DRIVEABILITY—CNG BI-FUEL—HESITATION ON ACCELERATION FROM STOPPED POSITION—VEHICLES EQUIPPED WITH 2.0L CNG BI-FUEL ENGINE ONLY	Article No. 01-19-5

FORD: 2000 CONTOUR

Figure 1 - Article 01-19-5

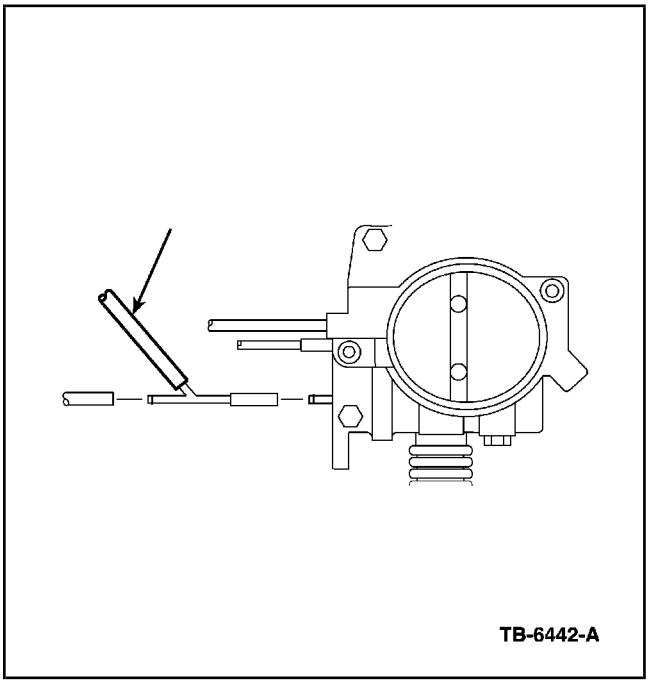
2. Inspect MAP line.
   a. Remove air box from throttle body.
   b. Remove MAP line assembly from throttle body as shown (Figure 1).
   c. Carefully remove MAP line assembly from vehicle.
   d. Measure Map line (should be approximately 28″ in total length). If longer than 28″, carefully disconnect MAP line from MAP tap and remove excess MAP line from end shown in Figure 1.
   e. Connect MAP line to MAP tap.
   f. Connect MAP line assembly to throttle body as shown in Figure 1.
   g. Carefully route MAP line to Compuvalve.

Figure 2 - Article 01-19-5

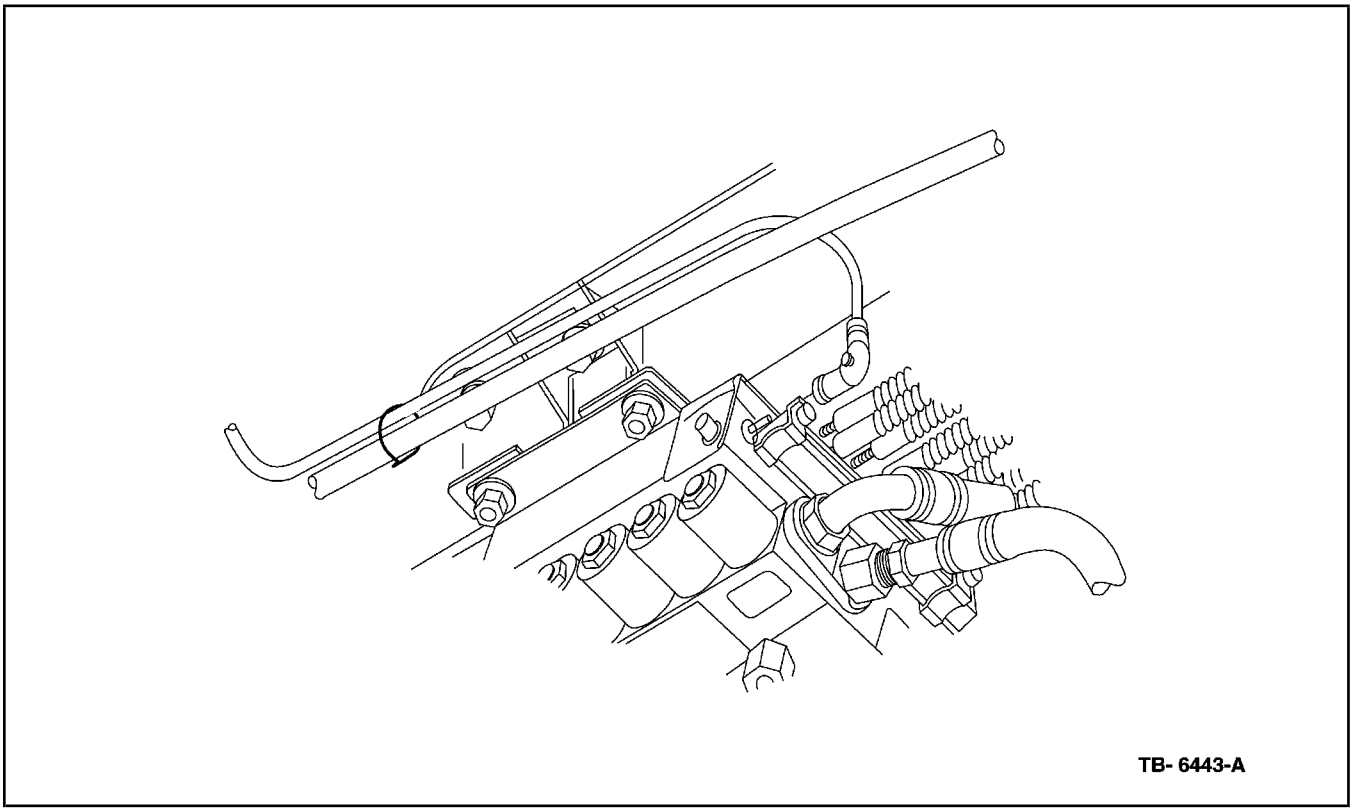
ROUTE MAP LINE IN FRONT OF SUB FRAME NEAR COMPUVALVE AS SHOWN IN FIGURE 2.

h. Tie wrap MAP line to power steering tube as shown in Figure 2.
   i. Install air box to throttle body.
3. Continue with Compuvalve installation as per Ford Workshop information for 2000 Bi-fuel Contour.
4. Leak check all connections removed for Compuvalve replacement. Use a quality leak reactant or equivalent over Compuvalve pressure fittings and lines. Leaks from the system will exhibit soapy bubbles. A mild soap and water solution may be used as an alternative.
